Office Action Summary

10/665,158

TANIGUCHI, TORU

NON-FINAL OFFICE ACTION

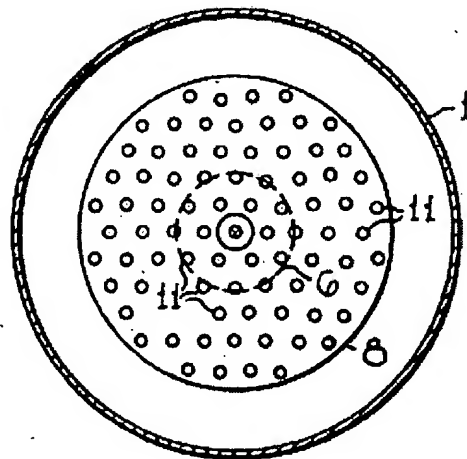
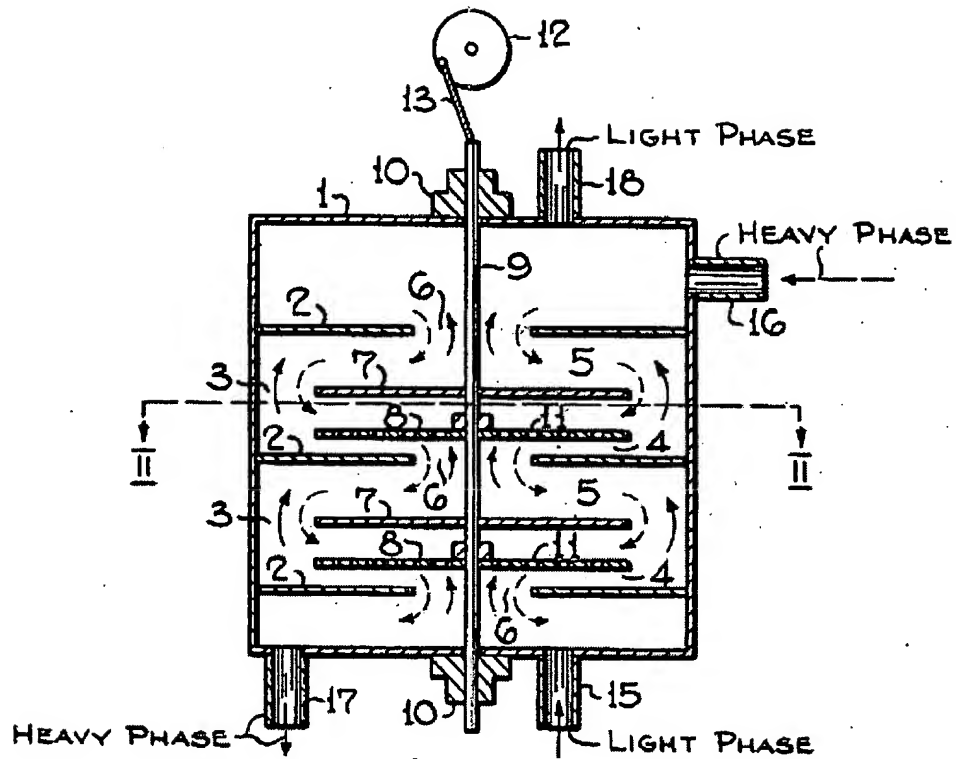
19. **Claim 1 is rejected under 35 U.S.C. 102(b) as being anticipated by Fenske et al. (US 2,667,407).**

The patent to Fenske et al. discloses an agitation apparatus in Figs. 1-2 as seen below comprising a casing 1; agitation body with a shaft 9 connected to vibration source 12, 13; blades 7, 8 on the shaft with blades 8 being apertured at 11 - Fig. 2; openings 15-18 into the casing capable of being employed as either inlets and/or outlets; agitating chambers 4 separated by divider plates 2 along the length of the casing 1; the upper or the lower chamber (proximate 6 or 9 in Fig. 1) may be termed a pre-agitation chamber to which the openings 15, 17 or 16, 18 are attached; the blades inherently being capable of being changed - note the blades 7 and 8 are configured differently.

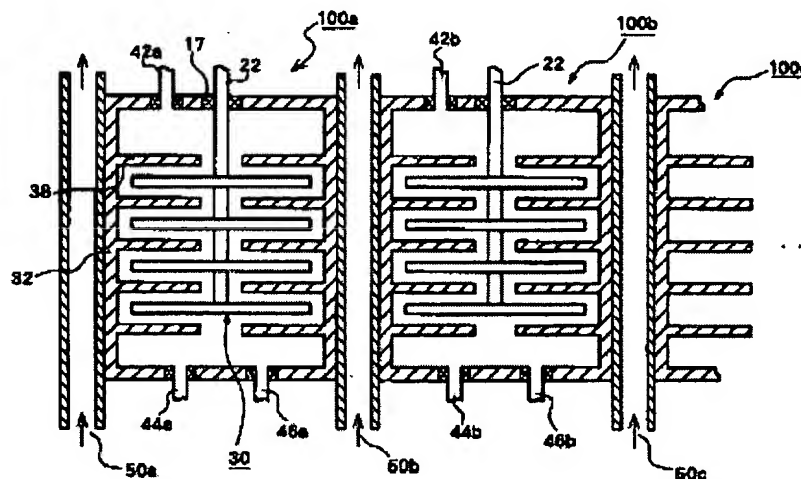
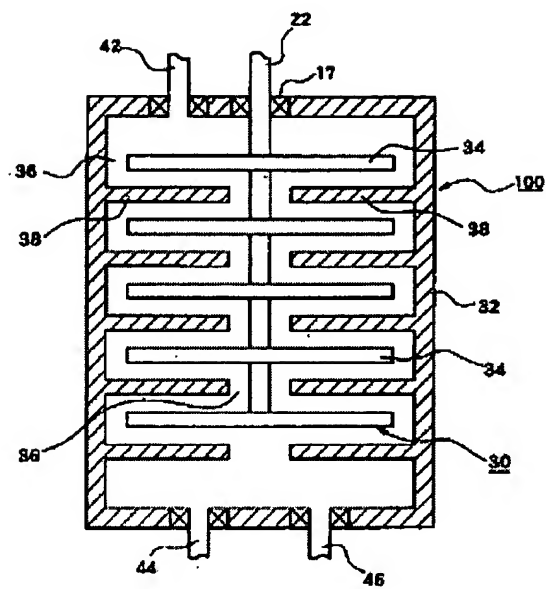
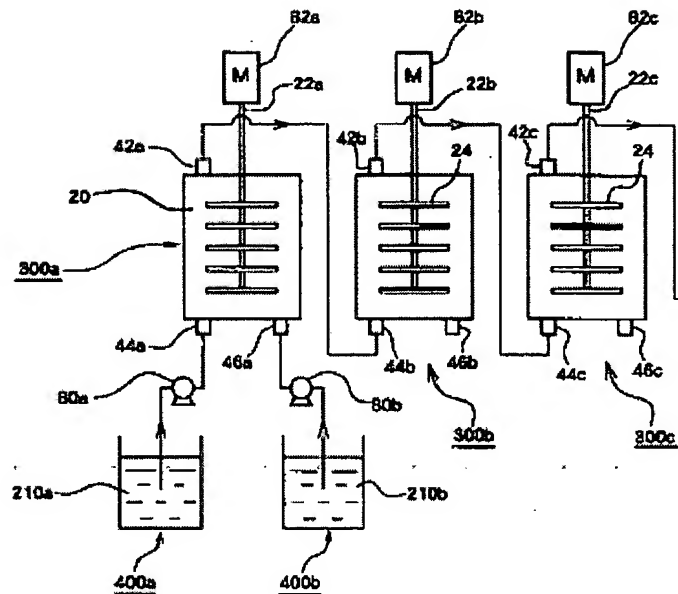
20. Claim 1 is rejected under 35 U.S.C. 102(b) as being anticipated by JP 2001-239140.

JP 2001-239140 discloses an agitation apparatus throughout the Figures including but not limited to the Figures seen below comprising a casing 100a or 100b or 32; agitation body with a shaft 22 connected to a vibration source (per the abstract); blades 30 or 34 on the shaft; openings 42a, 44a, 45a or 42b, 44b, 46b or 42-46 into the casing capable of being employed as either inlets and/or outlets (and note Fig. 23); agitating chambers separated by divider plates 38 along the length of the casing; the lower chamber may be termed a pre-agitation chamber to which the openings 44a, 45a or 44b, 46b or 44, 46 are attached; the blades inherently being capable of being changed.

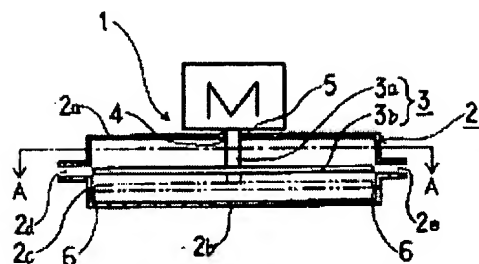
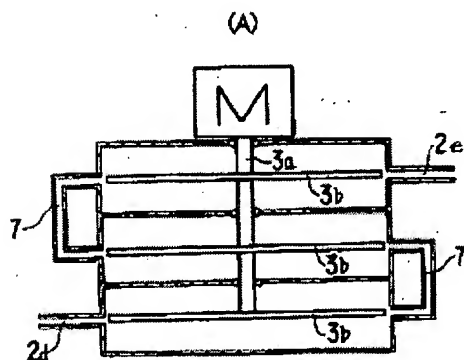
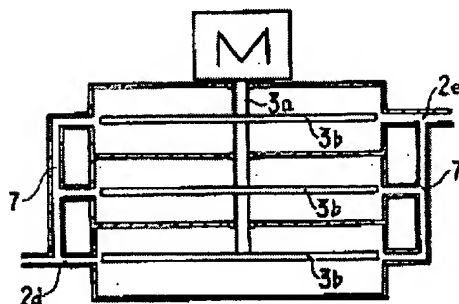
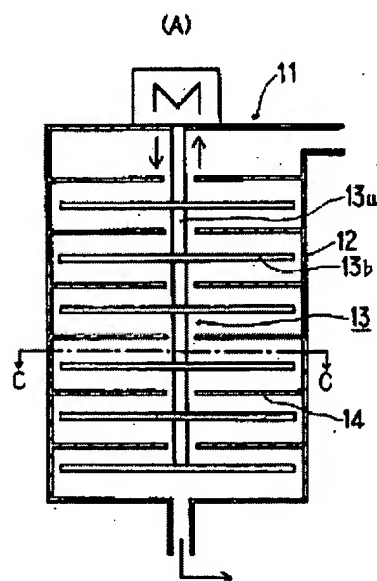
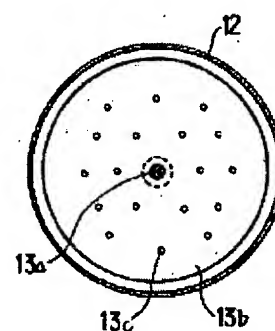
21. Claim 1 is rejected under 35 U.S.C. 102(b) as being anticipated by JP 11-169697.

JP 11-169697 discloses an agitation apparatus throughout the Figures including but not limited to the Figures seen below comprising a casing 12; agitation body with a shaft 3a or 13a connected to a vibration source M; blades 3b or 13b on the shaft; openings 2d, 2e, 7 into the casing capable of being employed as either inlets and/or outlets; agitating chambers separated by divider plates along the length of the casing as seen in the Figures; the upper or lower chamber may be termed a pre-agitation chamber to which the openings 2e, 7 or 2d, 7 are attached; the blades inherently being capable of being changed.

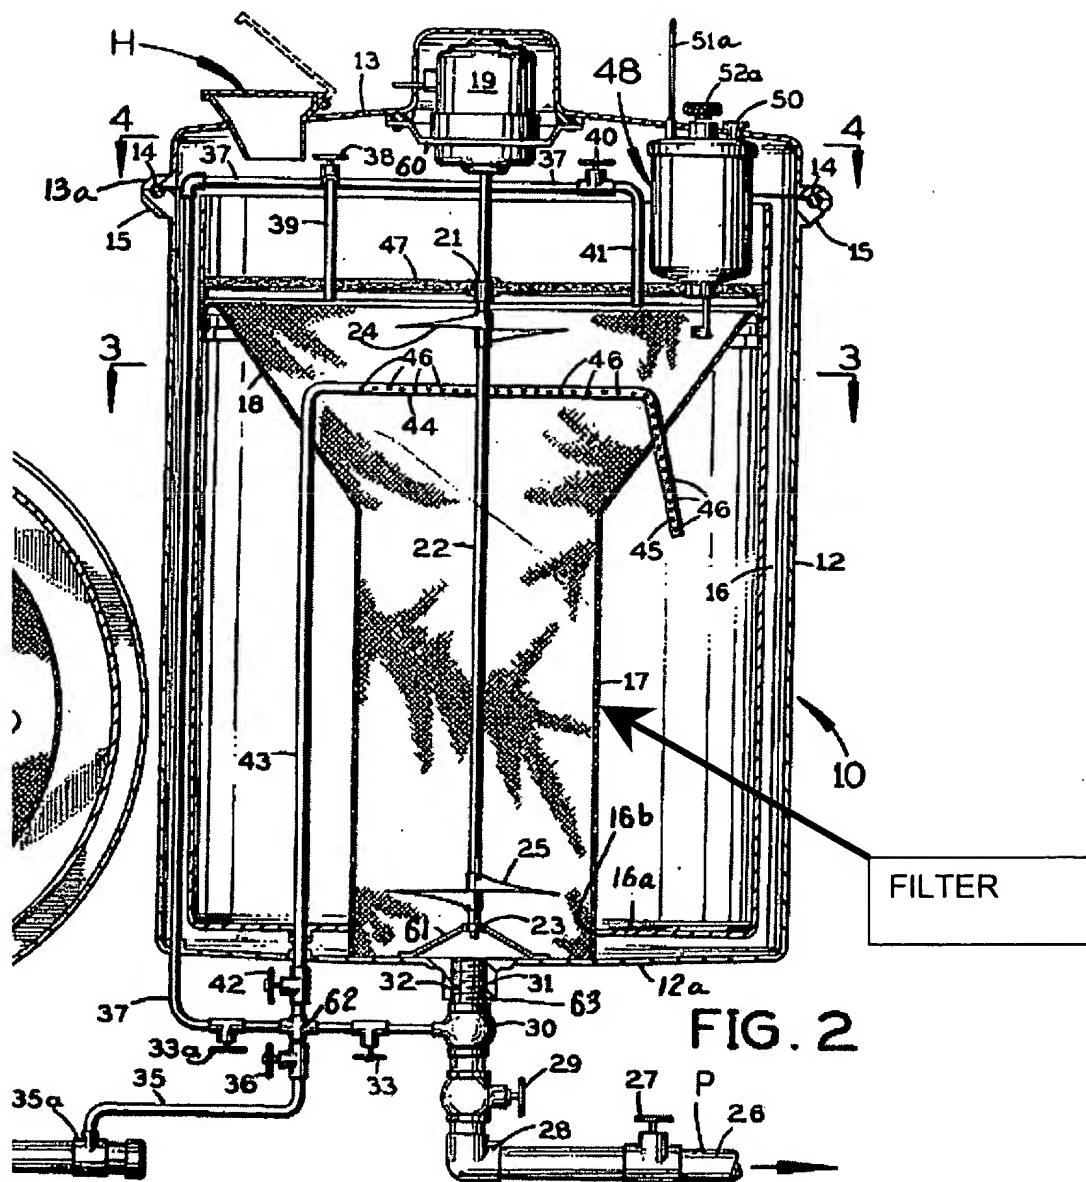
23. Claim 5 is rejected under 35 U.S.C. 103(a) as being unpatentable over Fenske et al. (US 2,667,407), JP 2001-239140 or JP 11-169697 in view of King (US 4,099,267).

Fenske et al. (US 2,667,407), JP 2001-239140 or JP 11-169697 do not disclose a filter enclosing the agitation body. The patent to King discloses a casing 12 having an agitating body with a shaft 22 and blade 25 thereon wherein the agitation body is enclosed by a filter 17. It would have been obvious to one having ordinary skill in the art, at the time applicant's invention was made, to have provided the casings of Fenske et al. (US 2,667,407), JP 2001-239140 or JP 11-169697 with a filter therein enclosing the agitation body as disclosed by King for the purpose of preventing undissolved solids from passing therethrough (col. 4, lines 62-65).
